WESTBANK FRYE HIGHRISE 707 TERRY AVE

WESTBANK CORP | Project 3021510 | East Board DRB Recommendation Meeting | 09.21.2016

PERKINS+WILL

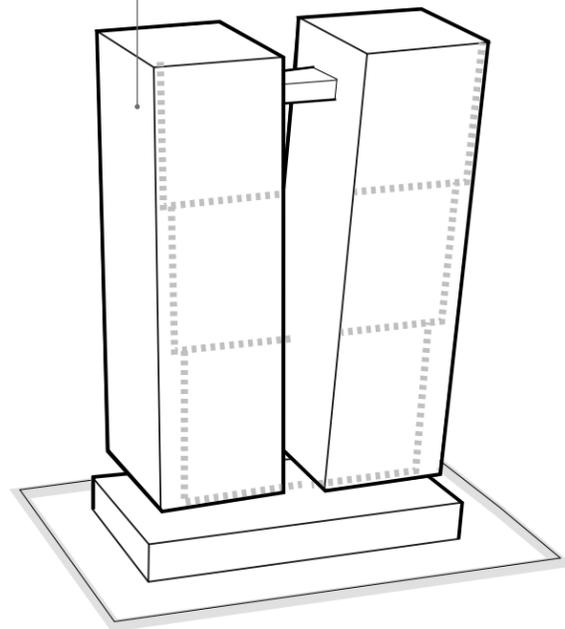
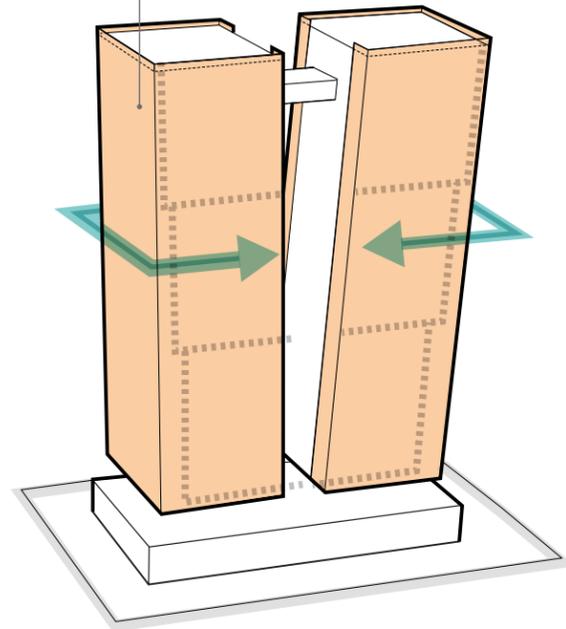
The Board supported the massing scheme from the EDG proposal of an iconic building shape.

The Board suggested a facade system that would manage solar gain and create architectural interest.

The architectural context and character emphasize positive neighborhood attributes, including a contemporary design with an expressive form. The sunscreens contribute to a unique cladding system. The sunscreens are envisioned as gossamer scrim which are perforated, creating a series of unique images.

The screens are conceptualized as a series of sliding panels that are wrapped around the tower, much like a canvas is stretched on a frame. The iconic Frye salon image is mapped onto the panels, adjusting scale, repetition, opacity, etc., thus creating an abstraction of the image.

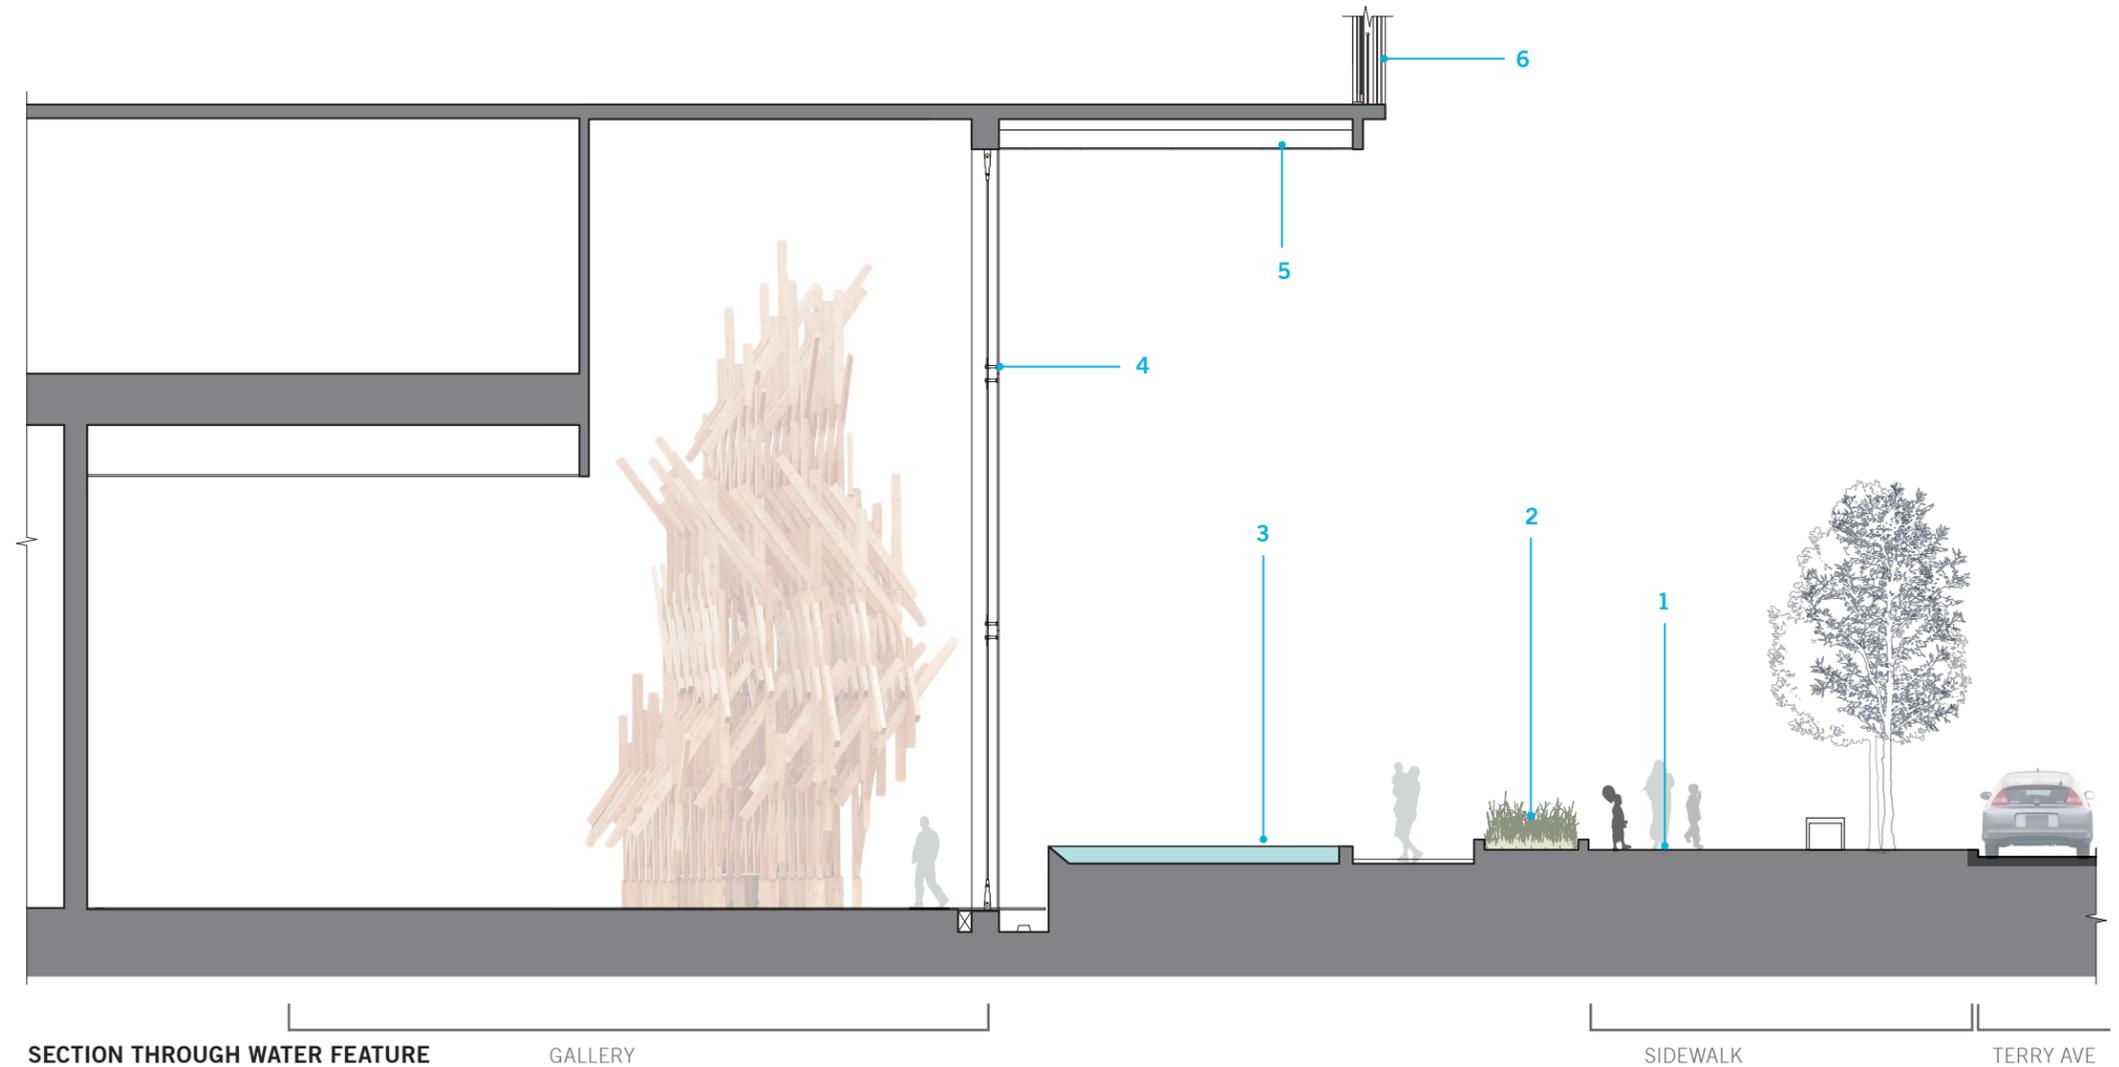
**Early Design Guidance -
Context & Site - Paragraph 2 (page 6)
Design Concept - Paragraph 3 (page 9)
Water Feature**

The Board was interested in seeing more development of the large water features shown at the ground plane. The Board directed the applicant to examine the role of water and the role of any water feature to ensure it supports **water as an interactive element/artful element** for interaction rather than as any kind of barrier.

**Early Design Guidance -
Context & Site - Paragraph 2 (page 6)
Design Concept - Paragraph 3 (page 9)
Public Interaction**

The Board weighed in on the arrangement of interior uses including lobby programming for public access; visual access throughout the site, and front lobby access for the public. Upper level public access would be great, but not required. The Board encouraged **active, visible studio space and community space**. The Board challenged the architects to create a building that feels **welcome to the public**. They note that water and planting, page 54 red number 4, could be a barrier. They directed the applicant to break the forms, create a plaza and make it more of a public space for water and planting that bleeds into Terry Avenue. More public seating is expected. At the next meeting the Board wants to see an **inviting and transparent interior space**, welcoming for visitors and the public.

**Early Design Guidance -
Design Concept - Paragraph 4 (page 10)
Water and Landscape**

The Board voiced their support for the preferred alternative, concept 3. The Board reiterated their direction to the applicant to follow the recommendations of the PRAP. They reiterated their expectation to see a **redesign of the water and planting areas** and cautioned the applicant to avoid creating barriers between the right of way and the building. The Board is pleased to see an iconic building concept beginning to take shape for the neighborhood.

The water feature has been substantially reduced to allow for more street front retail and activation. The two water features in front of the new building serve to reflect the art displayed within the lobby, as a visual amenity in the public realm. Recirculating water cascades down the sides of the fountain and is illuminated at night. Benches adjacent to the water feature help draw people to the entrance and water. The water features provide a visual connection with the adjacent reflecting pool at the Frye Art Museum, bracketing a civil street experience.

The Lobby and Gallery space will be open to the public during the normal hours the Frye Art Museum is open. Access to the Frye Museum parking has been designed to circulate through the lobby and gallery space.

(Page 44: First Hill Public Realm Action Plan - Winter 2015)

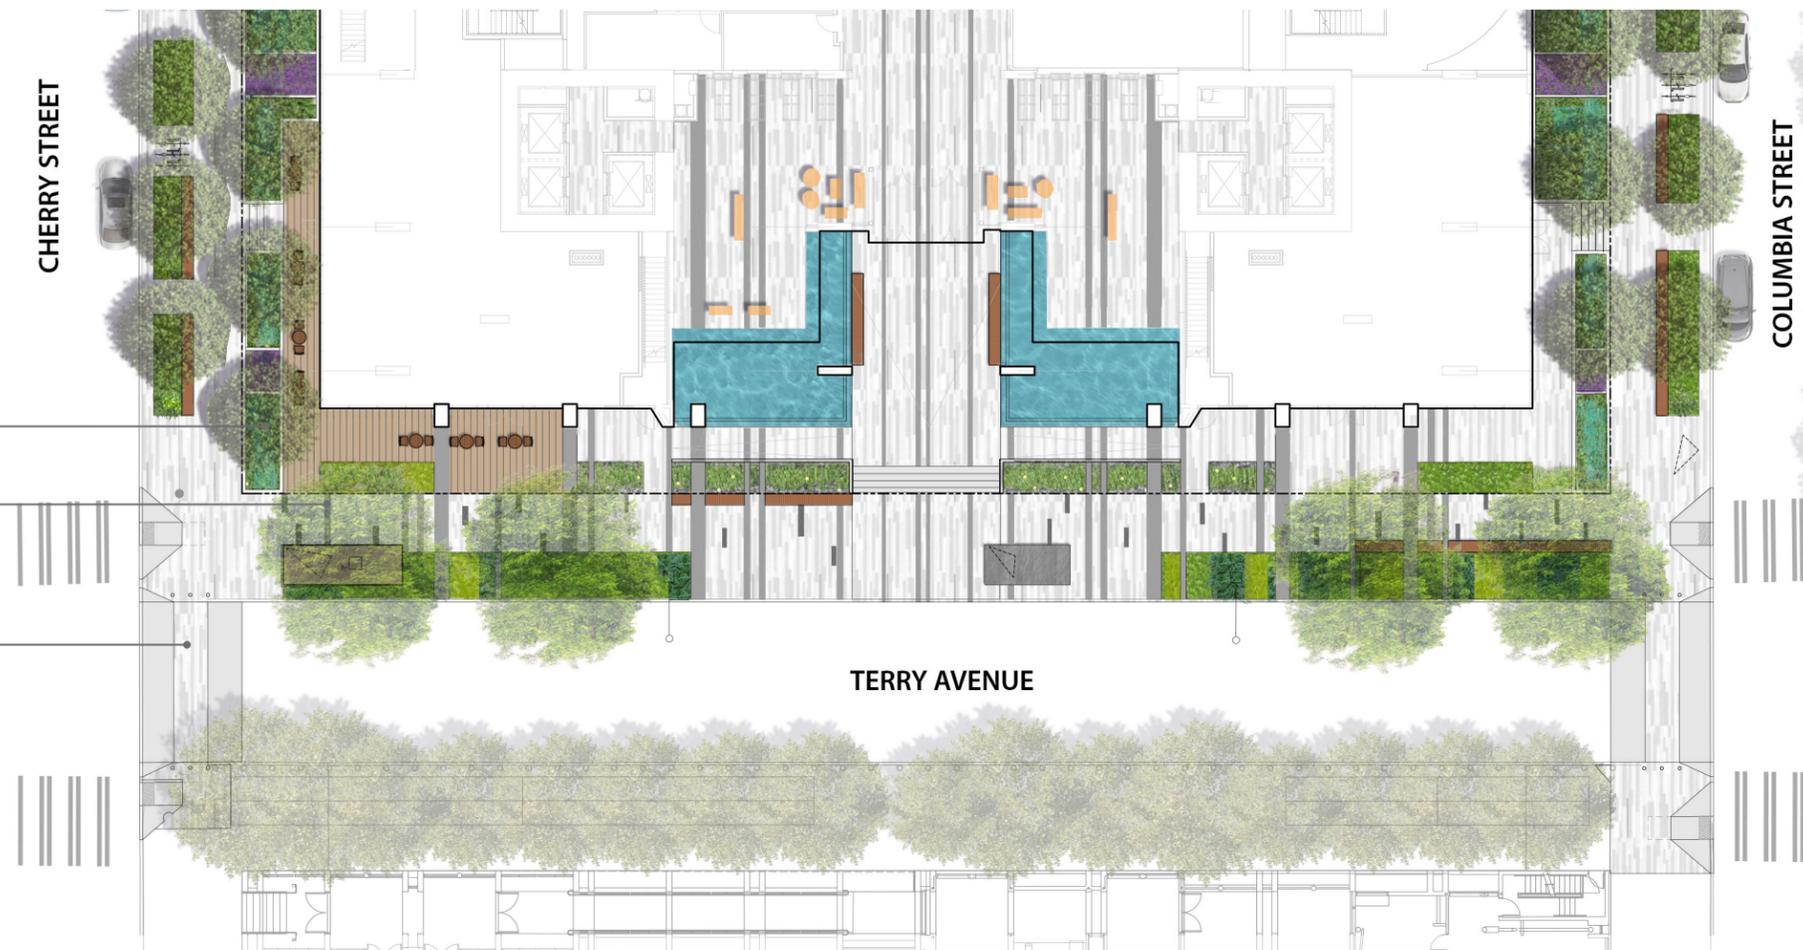
The Board supports the right of way planning elements of the Public Realm Action Plan (PRAP) and expects to see the PRAP direction for Terry Avenue at this site fully realized. The right of way design should integrate the neighboring urban pattern and accentuate the form-giving architectural elements of the new building. The street realm, the Frye Museum, and **museum streetscape should exhibit a cohesive concept and unified design.** The Board directed the applicant to examine the Frye Museum, O’Dea High School, and St. James Cathedral for design and urban planning cues.

At the Early Design Guidance Meeting, the Board directed the applicant to use the PRAP to design the Terry Avenue green street and to create a network of open spaces which link the Frye, the street, and this project for programmable outdoor activities. The Board emphasized that it is important to create a right of way that suppresses the vehicle and makes the **pedestrian the priority user.** Outdoor art, uses, activities, seating, and landscaping are a high priority to be located in the right of way and at the ground plane of this project. The Board directed the design team to design a **strong building entrance** to create an entry that better serves residents and the public in wayfinding: street to lobby.

The Board directed the applicant to build the **“Pedestrian and Parking Pocket”** as shown in the PRAP and pointed out the imagery shown on page 52 as a desirable **“woonerf”** design. The Board described the pedestrian pocket as curb less and that the location is a unique opportunity with the Frye Art Museum. The street design should bridge the right of way with **unique paving and landscaping** to create a plaza here. The Board would like to see the planting strip give way, in part, to public seating and have design elements bleed into the Terry Streetscape. The Board thought the opportunity was also unique in that there are aligned clients on both sides of the right of way and the designer should capitalize on the opportunity. The Board affirms their 100% support for the PRAP concepts.

Response: The applicant has substantially incorporated elements of the PRAP to the Terry Street curb line. The applicant met with SDOT/Susan McLaughlin for 30% SIP guidance on 4/7/2016. During this meeting Susan discussed the intent of the PRAP is to provide public space in street ROW in lieu of local park space. She encouraged the improvement of the streetscape as described in the PRAP, but noted the PRAP is not a requirement on this project.

- A mid block plaza space on Terry Ave is created through a combination of an enlarged forecourt and extended special paving to the curb. The plaza space opens up and connects to the Frye Museum across the street and provides opportunities for pedestrian activities and larger community events.
- 26 feet of additional seating is added with three benches facing the Frye Museum.
- 15 feet of additional seating is added at north end of Terry along the sidewalk.

Feature paving bands echoing the shear walls of the Frye have been extended across the forecourt and Terry sidewalk and through boulevard and forecourt planting to create a porous streetscape that bleeds into Terry Ave's ROW and increases connectivity. The raised cross walks on Cherry and Columbia have been provided between the Frye and the new building.

Infrastructure for food trucks and festivals have been accommodated (electrical receptacles and water hook up).
